DEVIATION REQUEST (Attach diagrams, figures, and other documentation to clarify request)

A deviation from the standards of or in Section **2.2.5.C – Urban Minor Arterial Access Criteria** of the Engineering Criteria Manual (ECM) is requested.

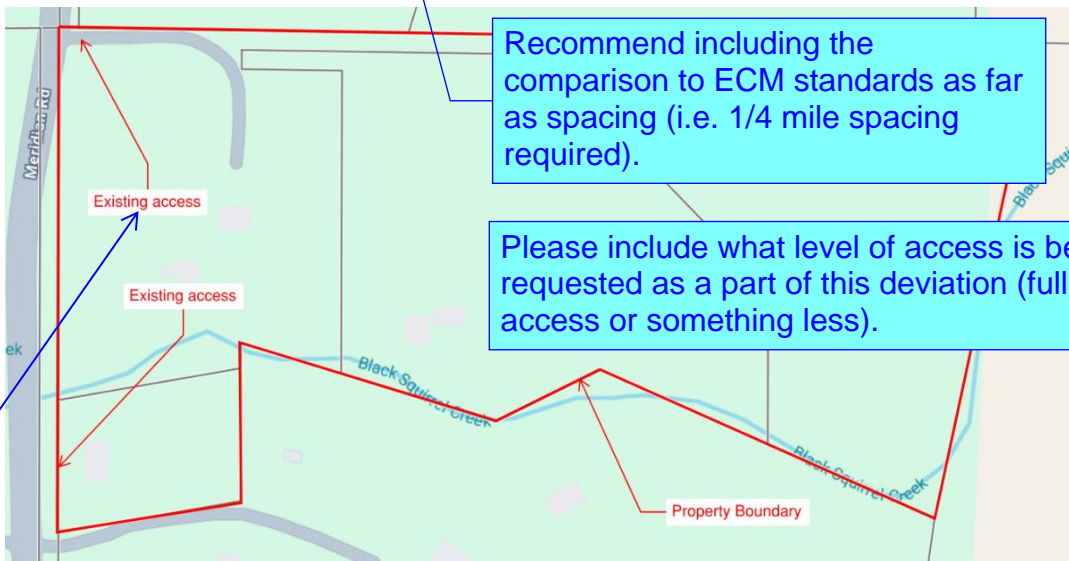
It would be helpful if the figure showed Latigo Blvd spacing since that is why a deviation is needed.

Please label the access point for which the deviation is requested.

DATE APPROVED: 12/31/05	Rural Local Roadway	
DESIGNER: John A. McCarty	Standard Cross Section	
REVISION DATE: 12/22/05	FILE NAME: SD_2-11

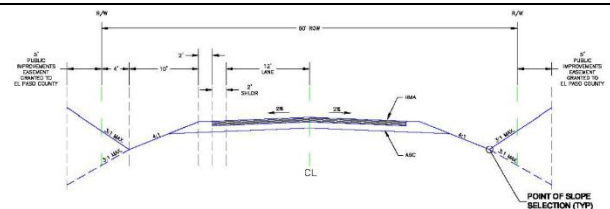
See previous comments. Justification should be focused on sight distance and access location suitability. Especially the site distance toward Latigo, since that is the purpose of this deviation.
